Docket Item #3 & #4
BAR CASE # 2017-0004 &
2017-0007

BAR Meeting
January 25, 2017

ISSUE: Partial Demolition and Alterations

LOCATION: 1019 Cameron Street

1
A-0
PROPOSED ELEVATION @ CAMERON STREET
SCALE: 3/16" = 1'-0"

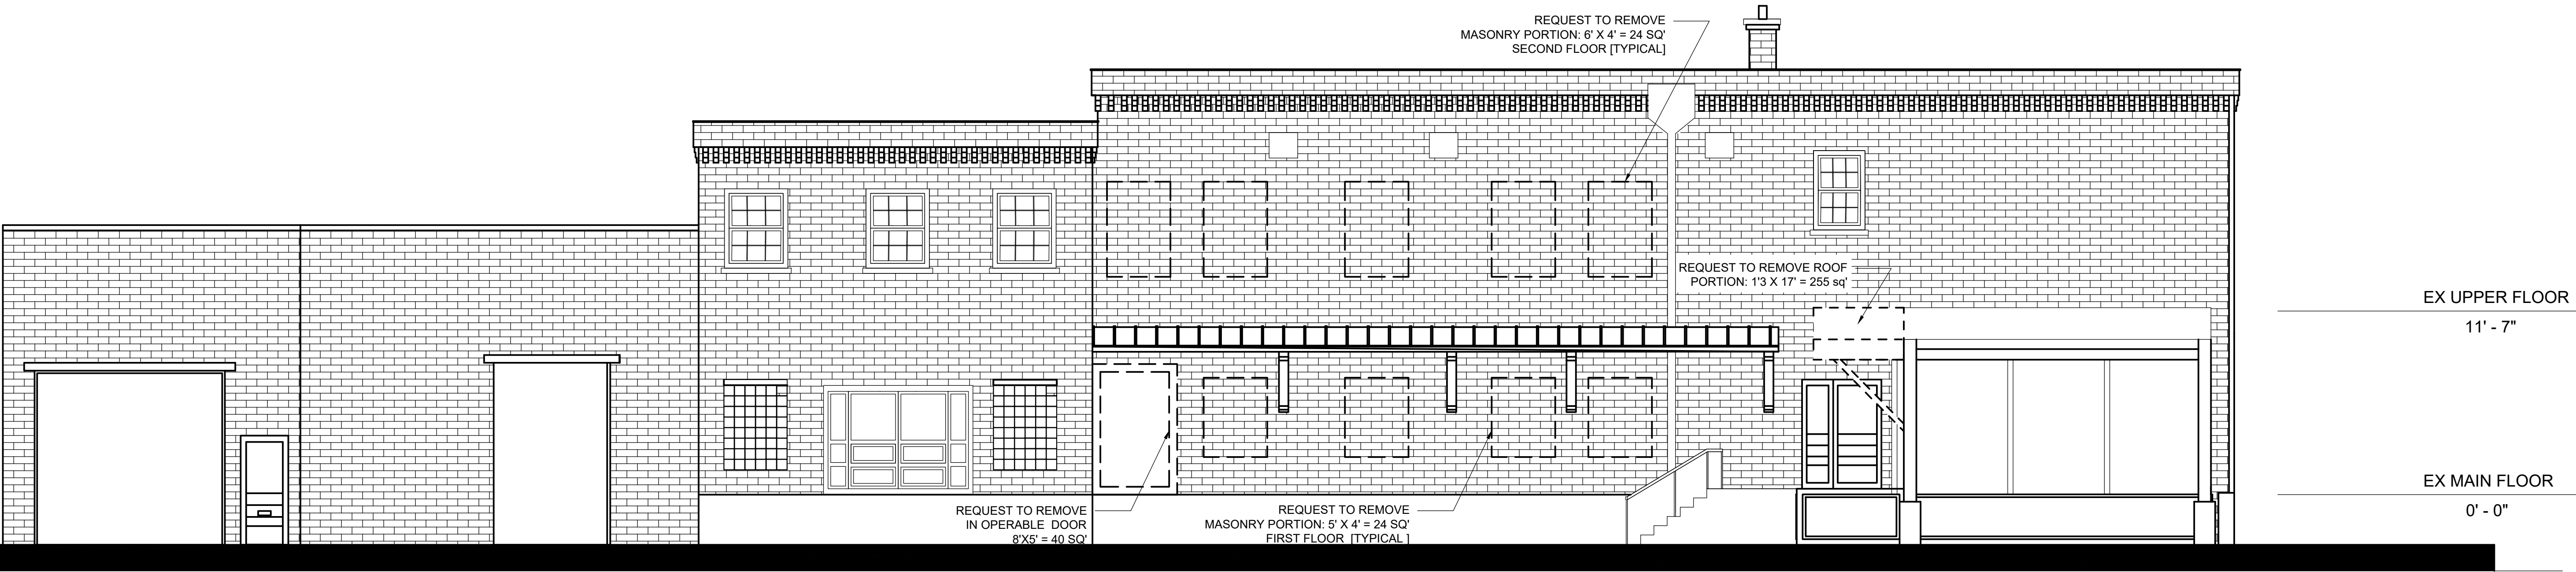
- Sheet A-2, zoning staff is not clear what the solid brick wall located towards the right of the proposed elevation (at Cameron Street) represents. Applicant will need to clarify.

A NING PLAN

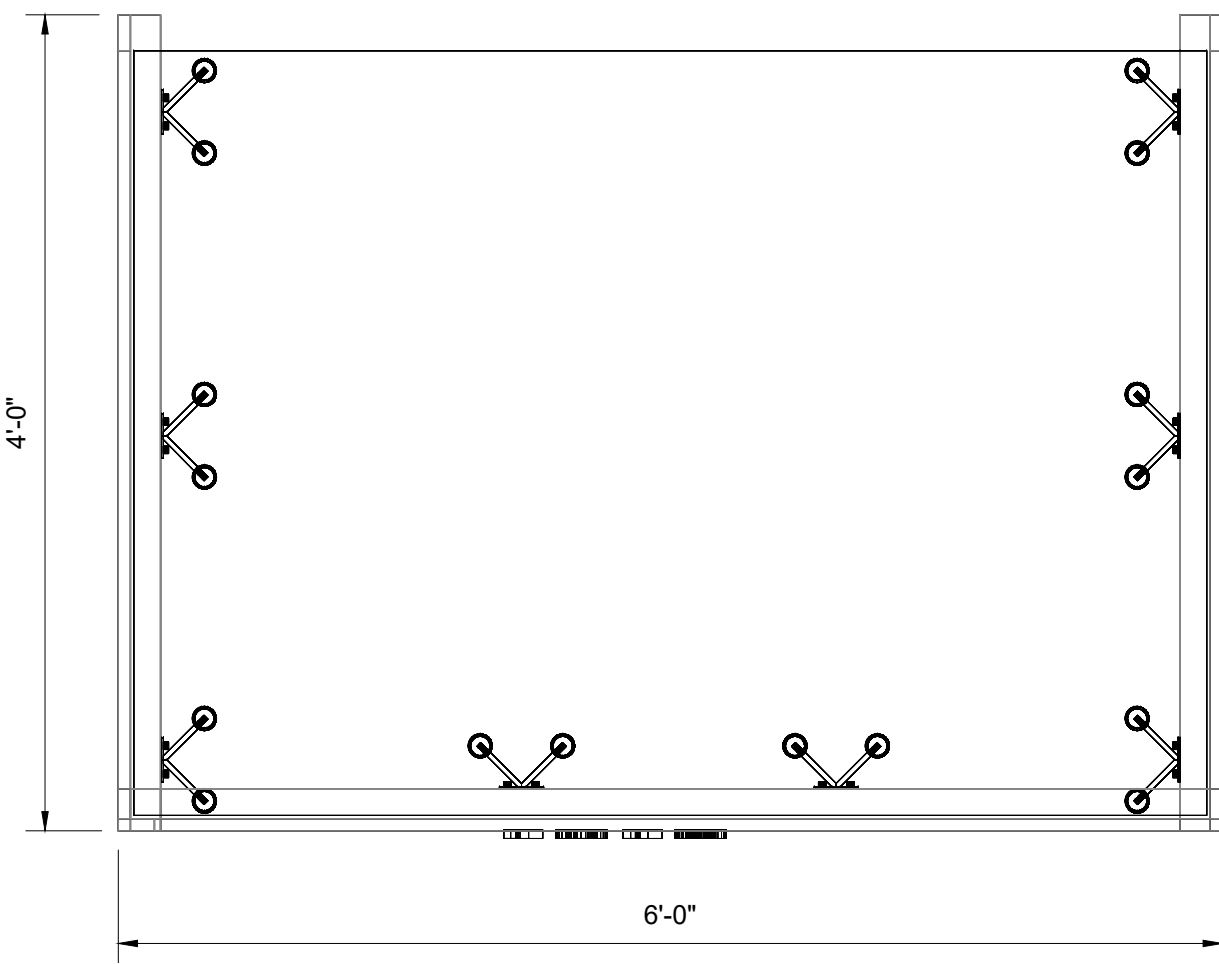
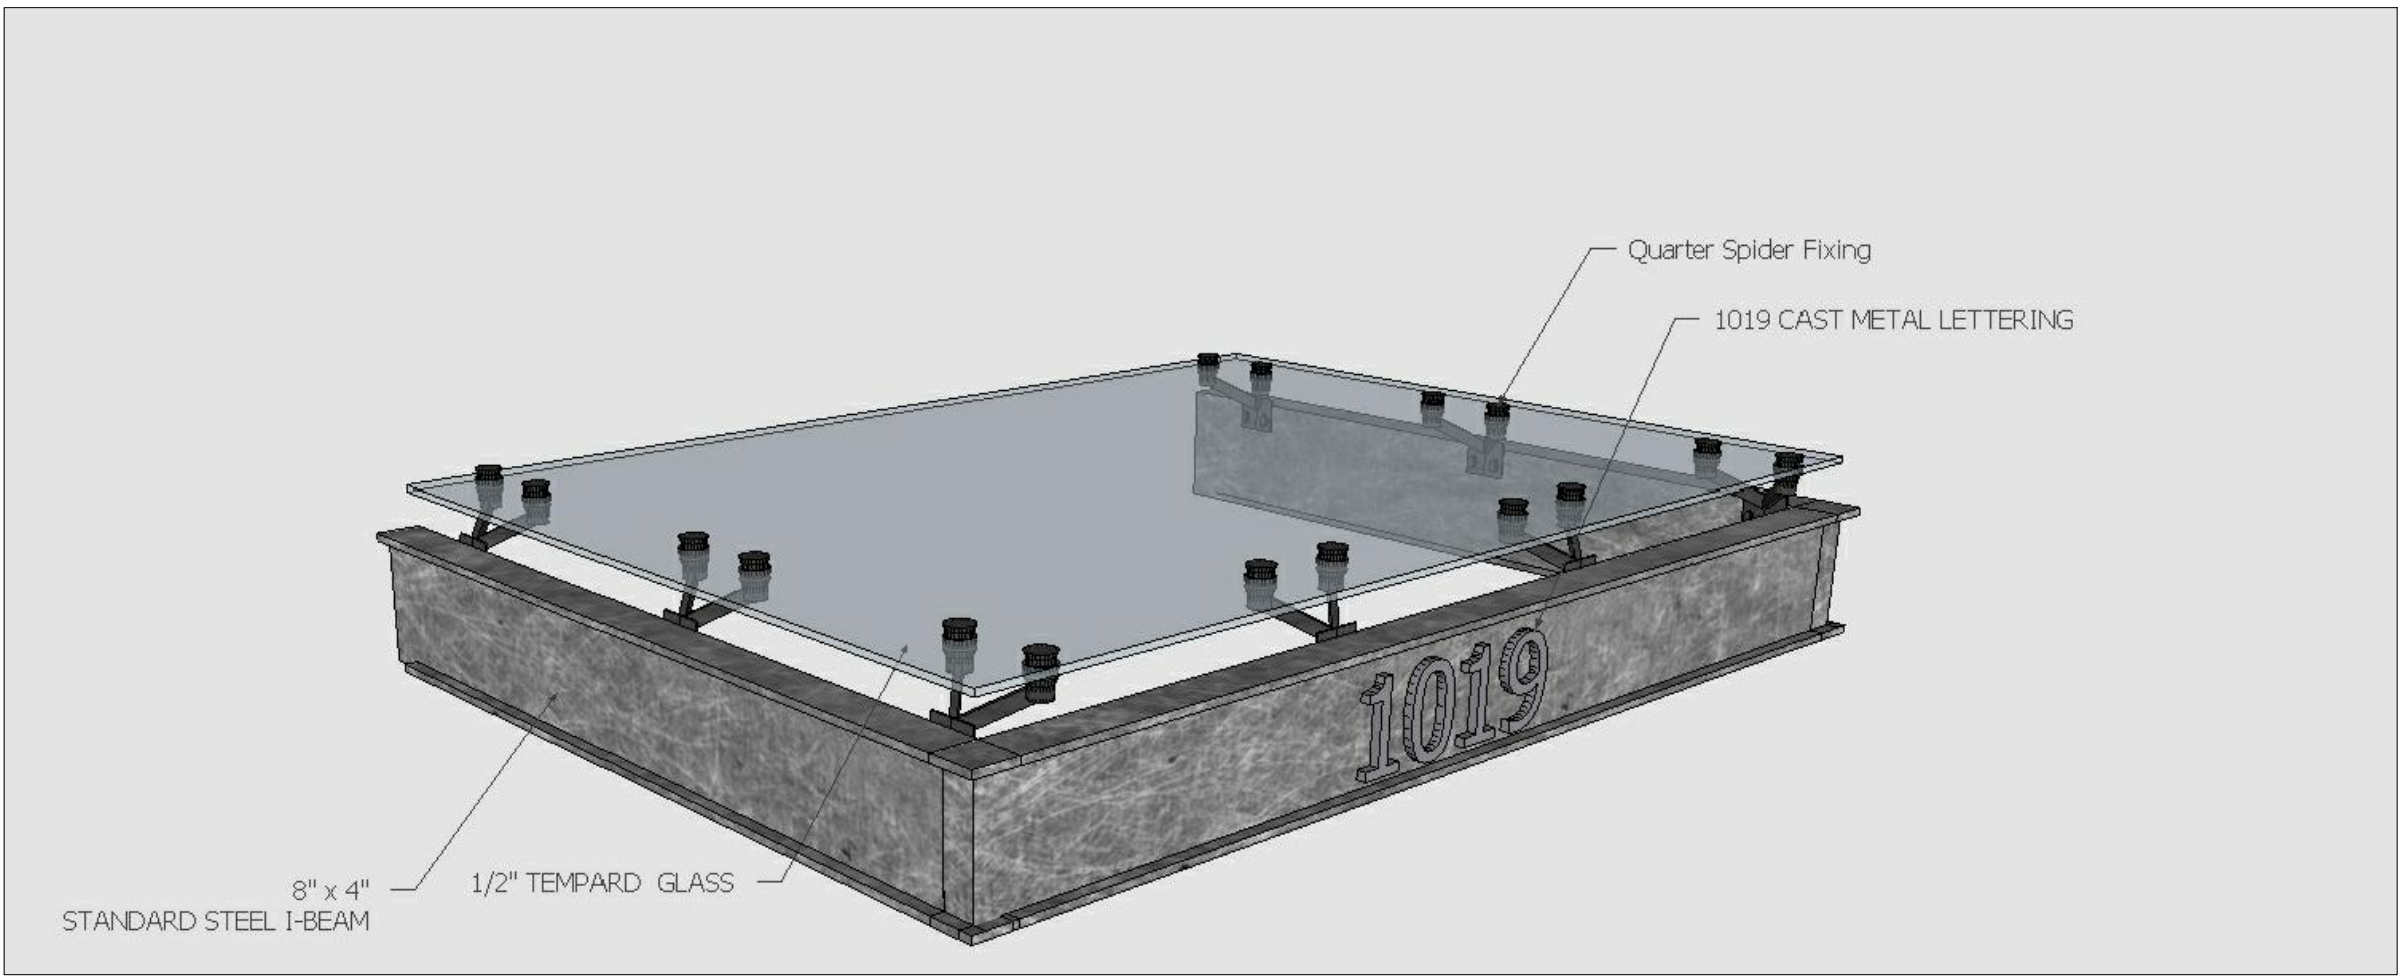
Regarding awnings over commercial entrances, the Design Guidelines note that "awnings should be appropriate and sympathetic to the historical style of the building" and "awnings should not overwhelm or obscure the architecture and decorative features of historic buildings." Staff considers the proposed awning to be more of a canopy than a more common fabric awning. The new awning is stylistically compatible for this industrial building and does not attempt to be a historicist element made to look old. Therefore, staff supports the minimalist and modern glass and steel awning as proposed as it will allow the historic building and elements to remain visually prominent.

- Applicant must submit a plat with the proposed awning (facing Cameron Street) shown. Per Section 5-2-29(d) of the City Code, the encroachment appears to be permitted. Please provide dimensions on elevations.

Canopies, awnings and marquees. Canopies, awnings and marquees suspended from a building or structure with no ground supports, having a clearance of at least eight feet above a sidewalk, extending no more than four feet beyond the front property line, and extending to no more than one foot from the established curb line, may be erected.
